Turbo HD DVR V3.4.81_Build170227 Release Notes (2016-03-03)

Reason of Upgrade

This version deletes **Hiddns** and **IP server** service, newly support **Hik-Connect.**, newly support **AHD/CVI 1080P lite mode**. This version is only suitable for DS-71/7200HGHI-Fx, DS-71/72/73/8100HQHI-Fx/N, DS-72/73/76/81/9000HUHI-Fx/N. Add some new functions, modify some functions, enhance products quality and meet customers' requirements.

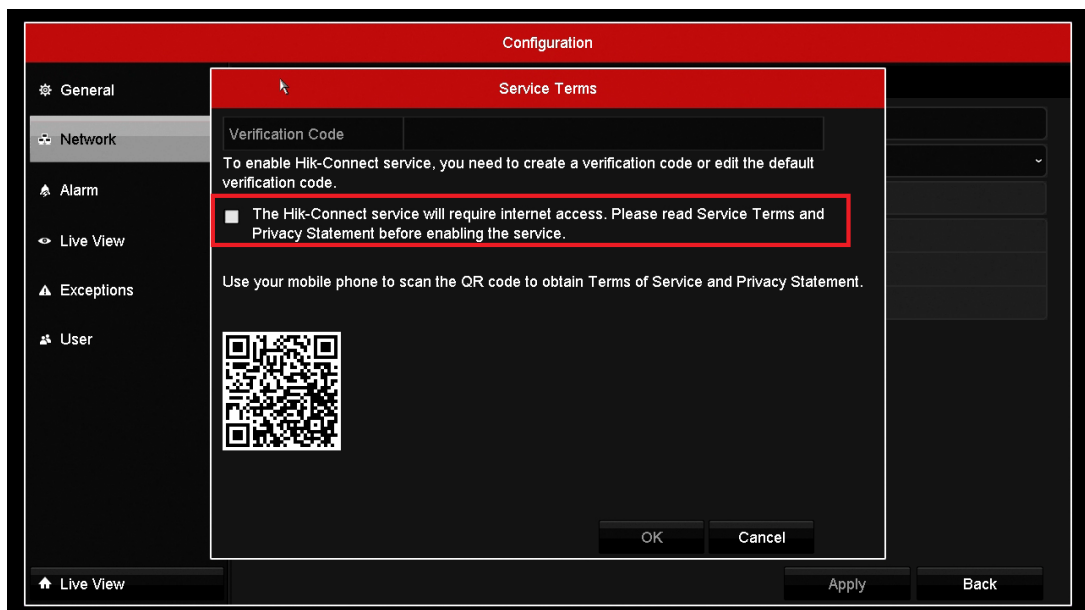
- i. **HGHI-F&HQHI-F/N Series newly support AHD/CVI signal 1080P lite mode.** (TVI signal 1080P lite mode has been already supported in previous version)
 - 1) When 1080P lite mode is enabled, all channels support 1080P TVI/AHD/CVI signal input.
 - 2) The encoding and decoding ability of AHD/CVI 1080P Lite are same with TVI 1080P lite

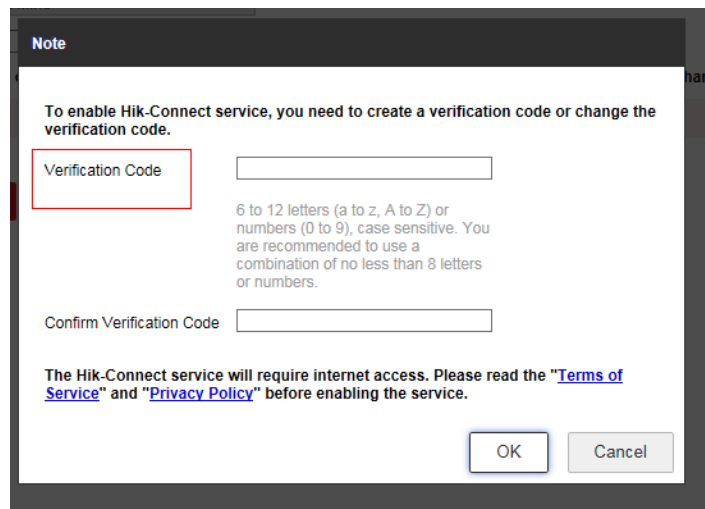
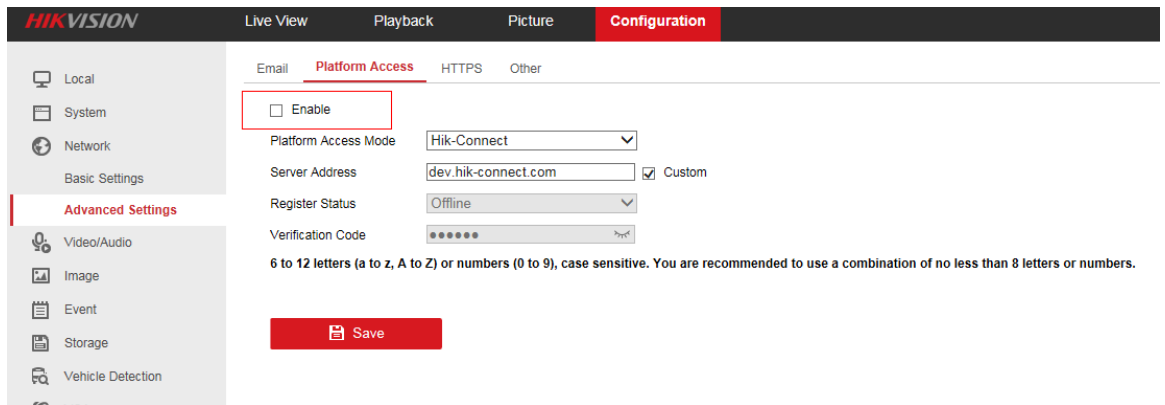
- 1) Delete **hiddns** and **IP server** service from DVR, replaced by **Hik-Connect** domain function; reserve third party DDNS: DynDNS, PeanutHull and NO-IP.
- 2) Hik-Connect (HC) function is not enabled **as default**. Based on security strategy, when users enable HC function, it will pop up a hint for creating a verification code and reading the **Terms of Service** and **Privacy Statement**. Users need to create a new verification code or edit the default verification code to enable HC service.
 1. On the interface of(GUI/4200/IE), to enable HC service, users need to check the checkbox below and set the verification code.

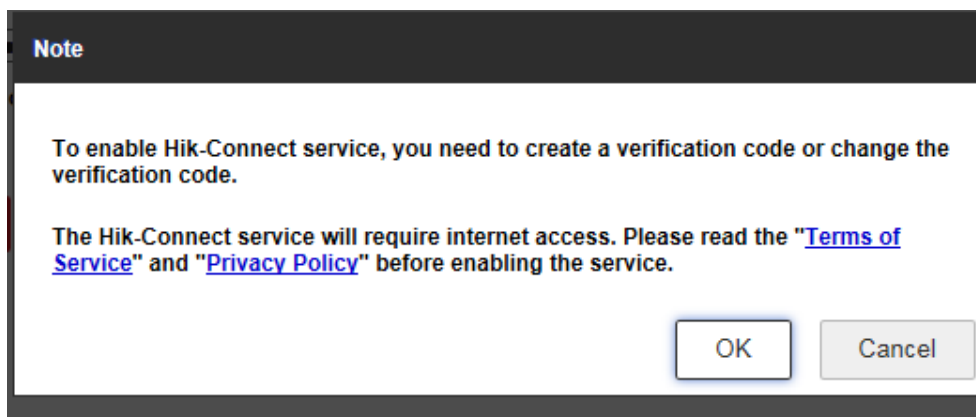
2. The new units require inputting custom verification code to enable HC.

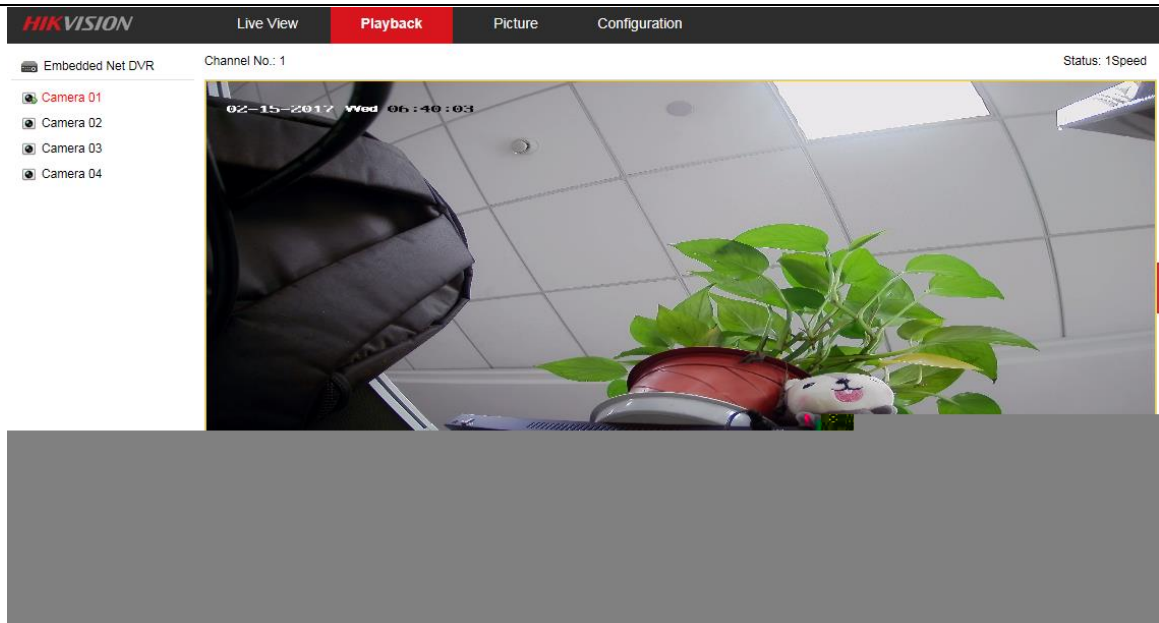
3. If the previous version device has enabled the HC(or EZVIZ) and updated to this version, HC service is still enabled.

vi. Hint for enabling 1080P lite.

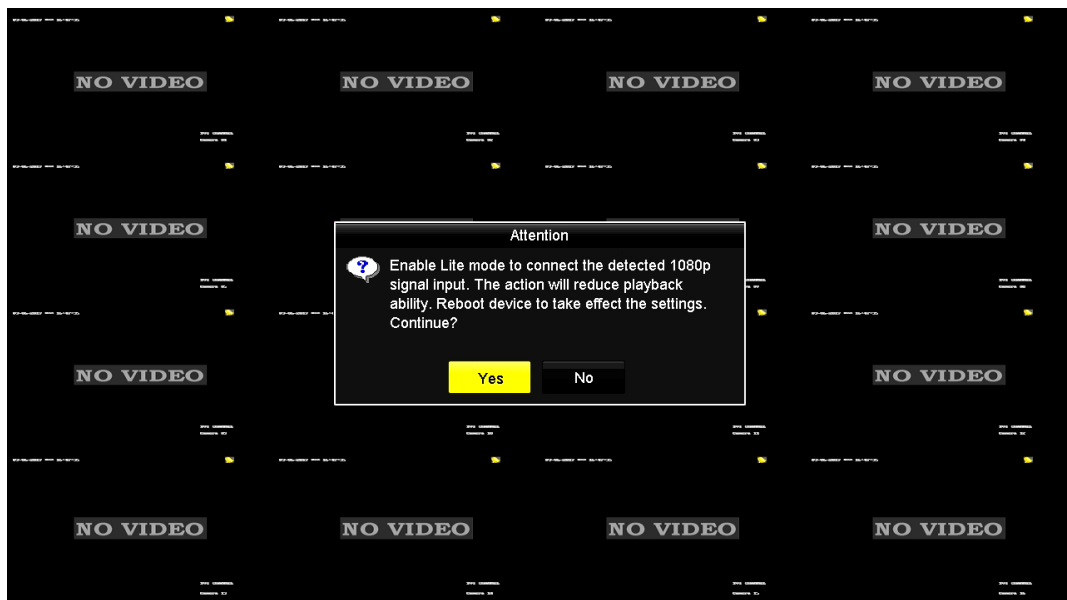
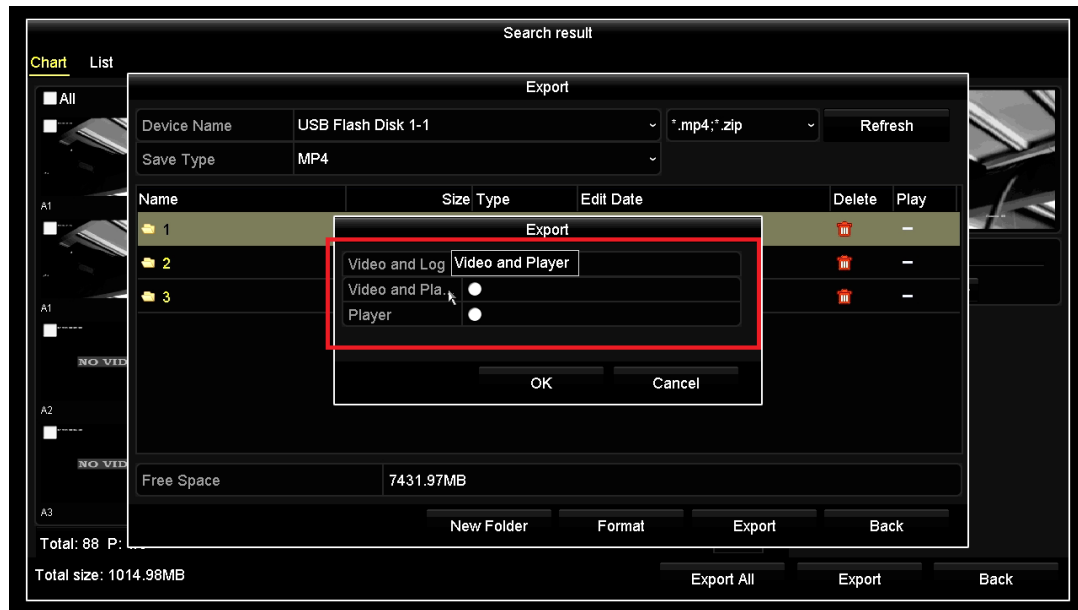
For HGHI-F series units, if the 1080P Lite mode is not enabled and the device is on the live view interface, when connecting the 1080P camera to the DVR, it will pop up a hint "Enable Lite mode to connect the detected 1080P signal input. The action will reduce playback ability. Reboot device to take effect the settings, Continue?"
